Reference No 4038P019901

**Heckington Fen Wind Farm
S36 Variation Application**

**up to 22 Wind Turbines with a increased rotor diameter
of up to 103 m whilst retaining consented tip height of 125 m**

**Wind Turbine Noise Impact Assessment
Appraisal**

Figure 4 Effect of a "stubby tower" on windshear.

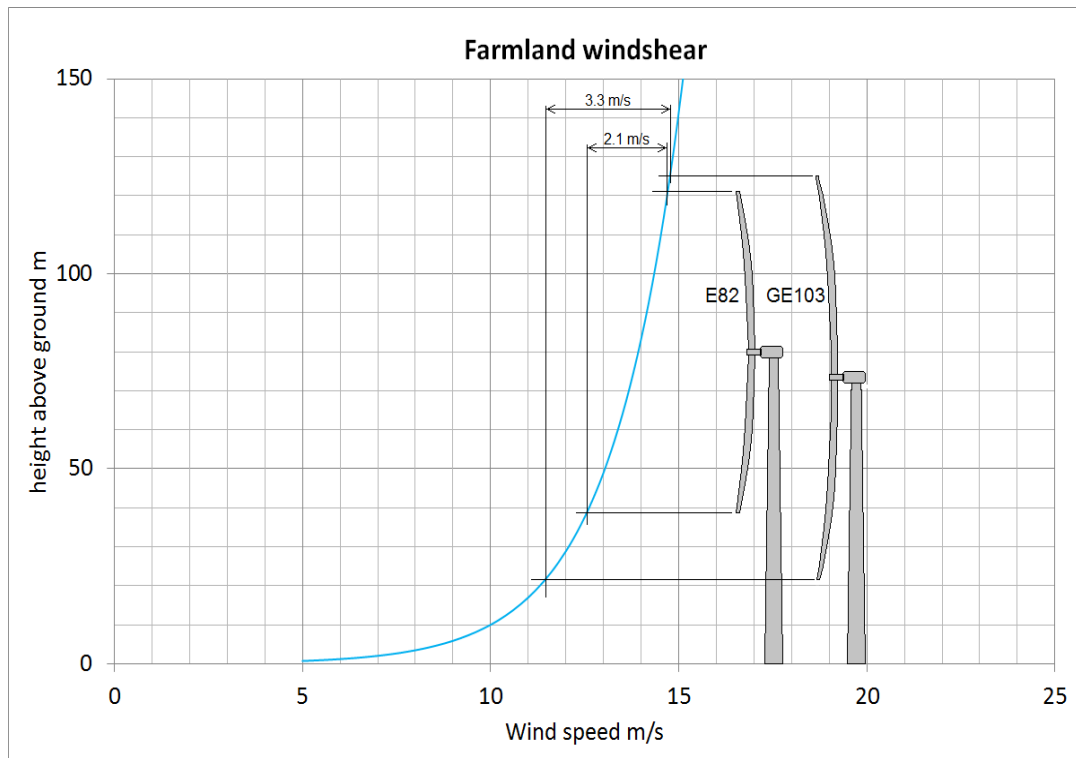
3.2.7 The chart in figure 4 shows, to scale, the vertical variations in wind speed (i.e. the wind shears) over the rotor disc of the originally proposed E82 turbine (2.1 m/s) and the currently proposed GE103 turbine (3.3 m/s, 57% more than for the E82 turbine). A 10 m/s wind speed at 10 m reference height wind speed is assumed, with a roughness length of 0.05 m, as quoted in ETSU-R-97 for “*farmland with some vegetation*”. This value however is based on measurements made during normal working hours, when wind shear is least. As noted above, after sunset wind shear can be much greater. I will now explain why high wind shear implies high levels of low frequency wind turbine noise.

Figure 5: EN3 guidance on wind turbine spacing.

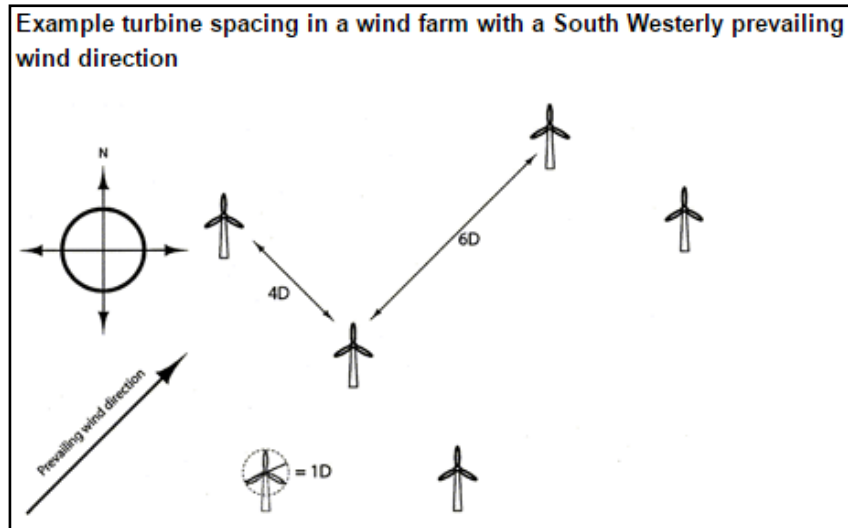
4.2.1 The proposed turbine positions are unusually closely spaced; planning guidance (EN3) proposes 4D x 6D (crosswind x downwind, where D is the rotor diameter). With the proposed 103 m rotor diameter, downwind spacings around 450 m and crosswind spacings around 300 m the guidance proposal of 4D x 6D has been abandoned in favour of 2.9D x 4.4D, a turbine density 1.9 times that of the recommended spacings. There are two consequences of this; the mean wind farm output power is significantly reduced, which does not concern me here, but the turbine noise emission power is significantly increased, due to inflow turbulence, which does concern me here.

4.2.2 The reason that the UK Government Planning Portal advises the 4D x 6D spacing of figure 5 as a minimum is that a turbine operating in the turbulent wake of another has a lower electrical output and a higher noise output than a turbine in clean airflow. Whilst the 4D x 6D spacing is advised in EN3 rather than mandated, the increased inflow turbulence characteristic of closer spacings invalidates turbine manufacturer's operational noise warranties. Published generation and noise data, being based on measurements of single turbines, can no longer be relied upon. I have not allowed for this in my NIA, but I would expect some margin below the ETSU limit to be reserved to accommodate it.

Figure 6: Applicant's derived background noise polynomials for all six background noise surveys.

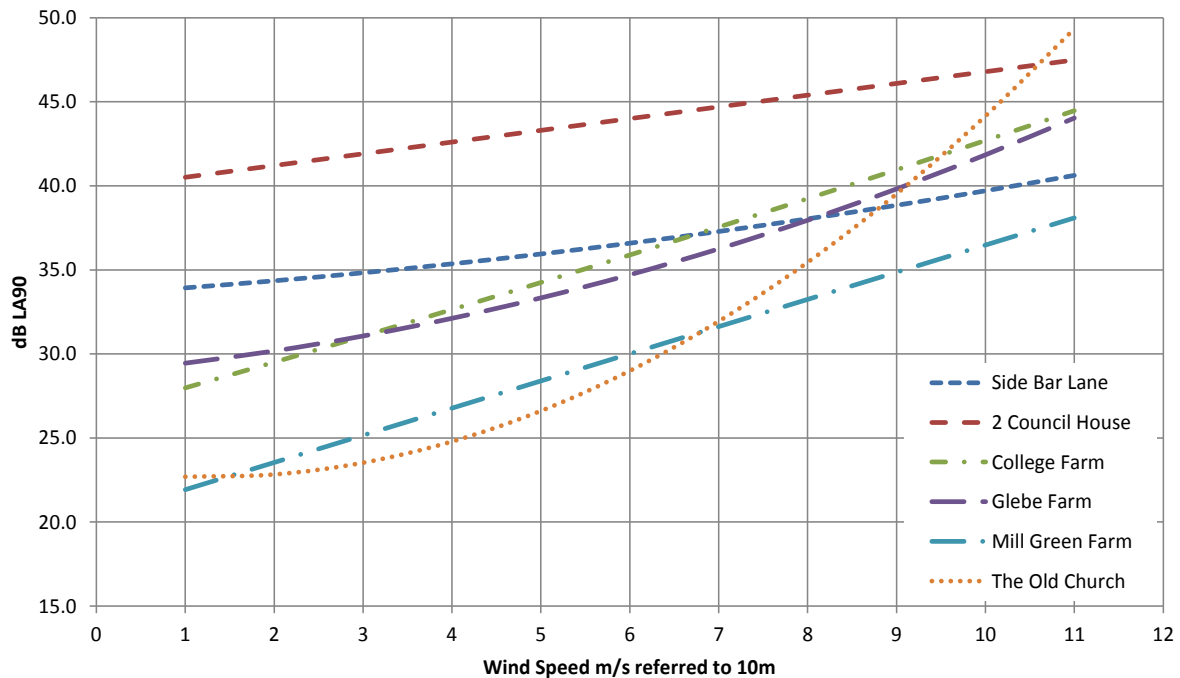
- 5.2.1 In the absence of the applicant's raw noise data is instructive to compare the measured noise levels at the six surveyed receptors, plotted in figure 6 above from the applicant's chart polynomial coefficients. With the single exception of The Old Church there is relatively little increase (5 to 12 dB) in the background noise level from 4 m/s (cut in wind speed) to 11 m/s; at The Old Church however the increase is 25 dB. The reason for this is explained in §4.3 below; essentially it is because the chosen microphone position was too close to trees and hedges.

5.5.11 For the avoidance of any doubt that the applicant’s statement quoted above is disturbingly wrong I refer again to my chart of polynomials in Figure. This background noise survey is deeply flawed, and therefore invalid for 2 Council Houses itself. It is also invalid for use as a proxy for any of the other six of the receptors listed above, and would have been for four of them even if it had been correctly executed.

Figure 16: Enercon E82 turbine proposed in original application compared with GEs 103 turbine proposed in variation application; both are shown to the same scale.

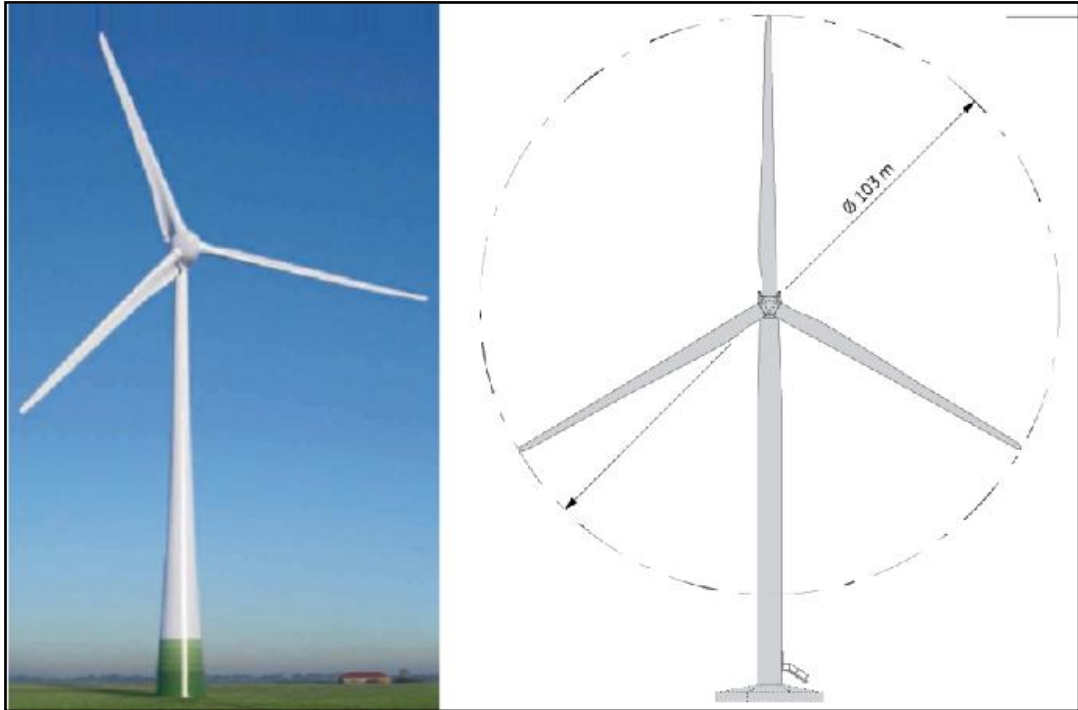
- 7.2.1 There are three factors associated with the proposed wind farm which will significantly affect its noise emissions, but to an extent that is difficult to quantify. The first is the "stubby tower" design; this is a major concern for the variation application, but is also relevant for the original design, as it will be seen in the appended turbine noise specification that Enercon offer the E82-2.3MW turbine with a range of five very different hub heights. These are illustrated to scale in figure 15. Thus the original application had already proposed the shortest tower available, at 78 m hub height, which has the highest probability of stall at blade zenith with the increased aerodynamic and very low frequency noise that this implies. Figure 16 shows the considerable difference between the original E82 turbine and the General Electric GEs 103 turbine proposed for the variation.
